HP 3400A RMS Voltmeter

MANUAL CHANGES

Manual Part Number 03400-90013

CHANGE NO. 1. Applies to Serial Numbers 2415A31171 and Above.

Figure CS-1. Figure 6-1 Changes (Change #4)

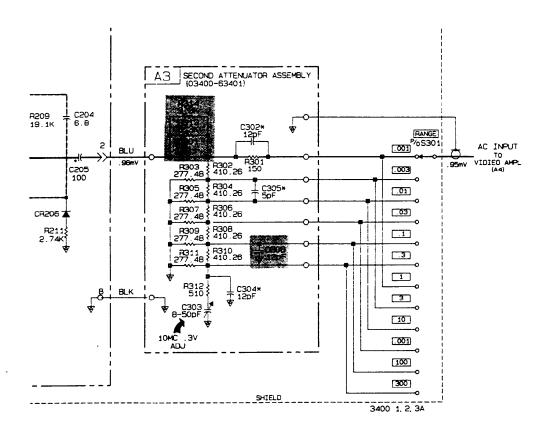
Section VI, Figure 6-1 (A1, A2, and A3 Schematic). Do the schematic changes in Figure 6-1 as shown in Figure CS-1 (in shaded area).

Reference Designation	HP Part Number	C	Oty	Description
Add:	 			
C301	0160-3402	2	1	CAPACITOR-FXD 1UF ±5% 50VDC POLYE
C306	0160-2259	5	1	CAPACITOR-FXD 12PF ±5% 500VDC CER
R313	0683-0335	2	2	RESISTOR 3.3K 5% .25W FC TC = -400/+800
R314	0683-0335	2		RESISTOR 3.3K 5% .25W FC TC = -400/+800

Figure A-1.
Figure 6-3 Component Locator Changes (Change #1)

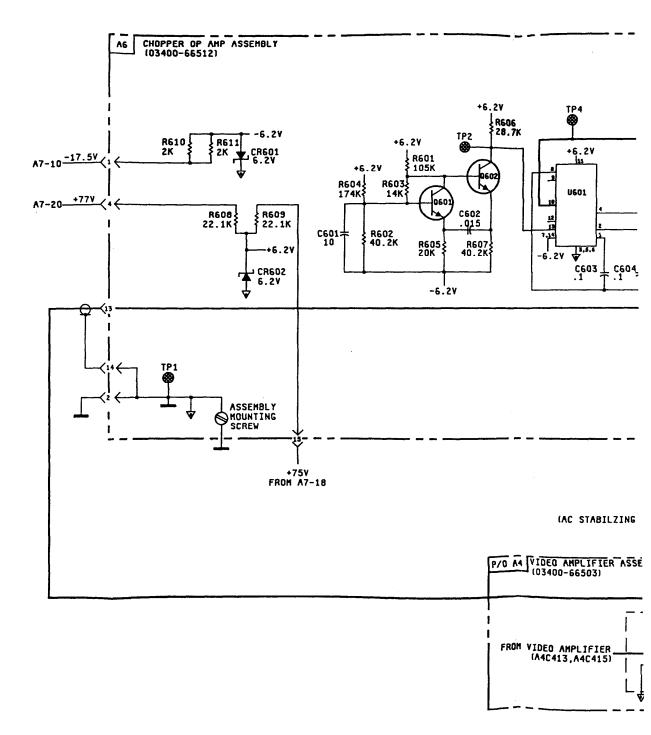
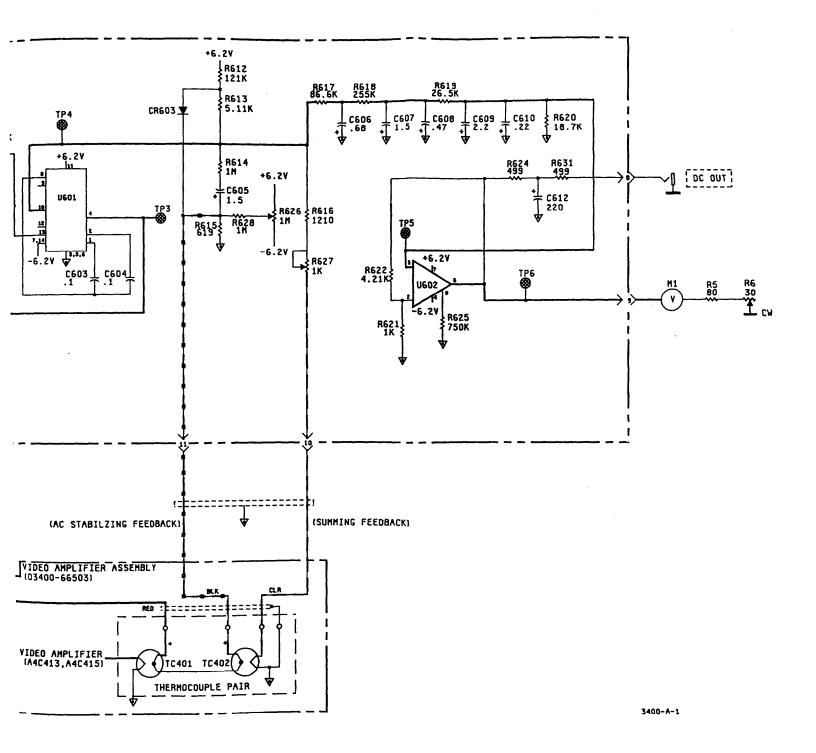
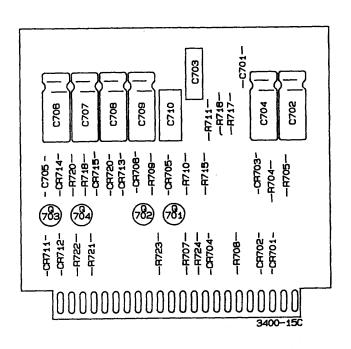
Reference Designator	-hp- Part Number	CD	Description
R621	0757-0280	0	Change to 1 K 1% .125W Resistor
R622	0698-3454		Change to 4.22 K 1% .125W Resistor
R625	0683-7545		Change to 750 K 5% .25W Resistor
R629	2100-3355		Delete 100K Potentimoter

Figure 7-2 3400A Top View

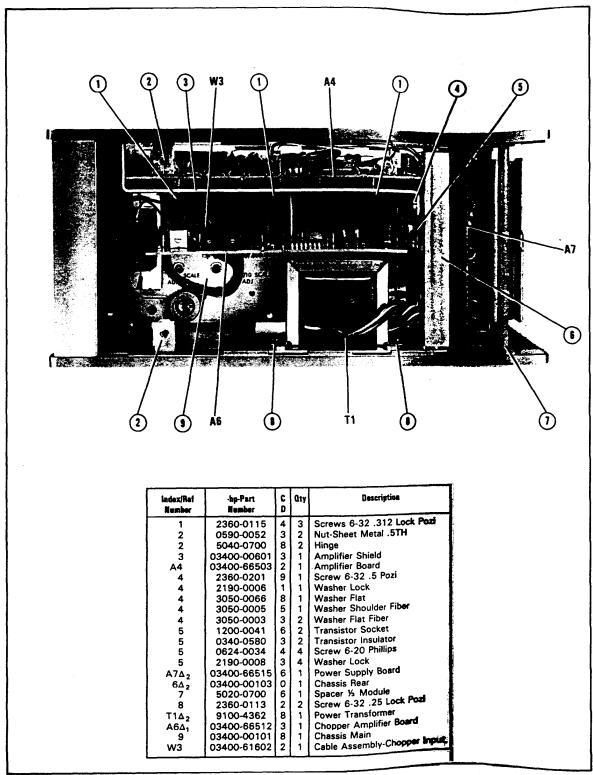
Section VII, Figure 7-2 Changes. Do the following changes in the table located in Figure 7-2.

Index/Ref Number	-hp- Part Number	C	Description
A7 6 T1	03400-00102	9	Change Part Number of Power Supply Change Part Number of Rear Chassis Change Part Number of Transformer

Figure 7-4 3400A Bottom View with Shield Removed

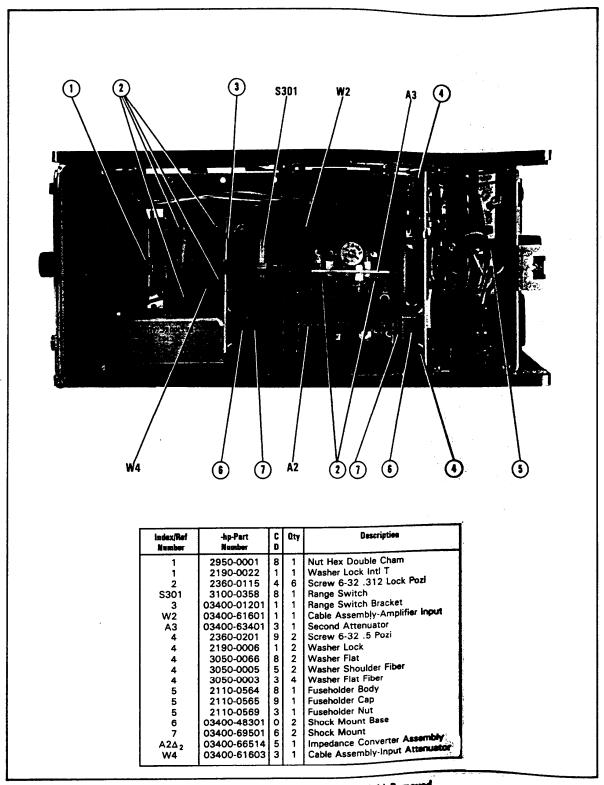
Section VII, Figure 7-4 Changes. Change the part number of the A2 Assembly from "03400-66514" to "03400-66502".

Figure 7-5 3400A Rear View

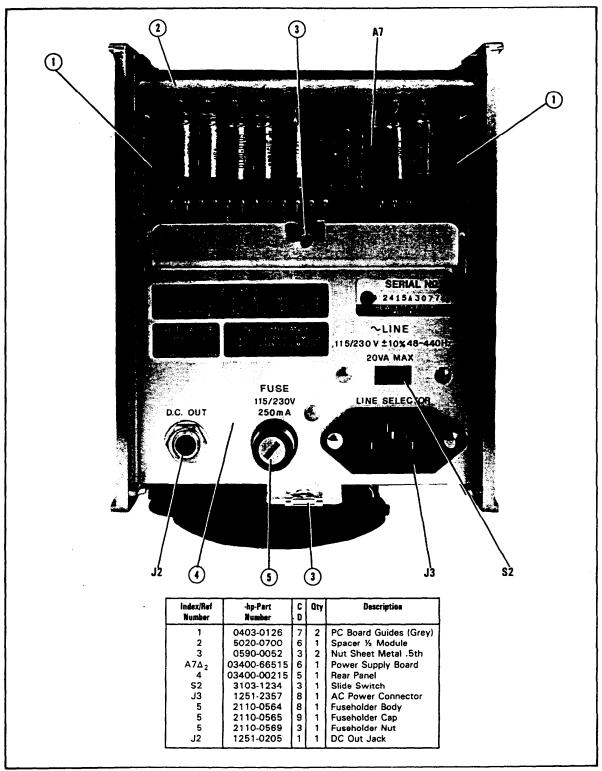
Section VII, Figure 7-5 (3400A Rear View). Change the -hp- Part Number of S2 in the table located in Figure 7-5 from "3103-1234" to "3101-1234".

Section VII, Figure 7-5 Changes. Change the part number of the A7 Assembly from "03400-66515" to "03400-66513".

Figure A-4.
Figure 6-4 Component Locator Changes (Change #2)

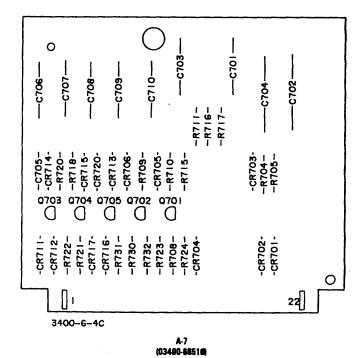
Section VI, Figure 6-4 Changes. Use component locator in Figure A-4 and schematic in Figure A-5. The shaded area on the schematic pertains to the changes.
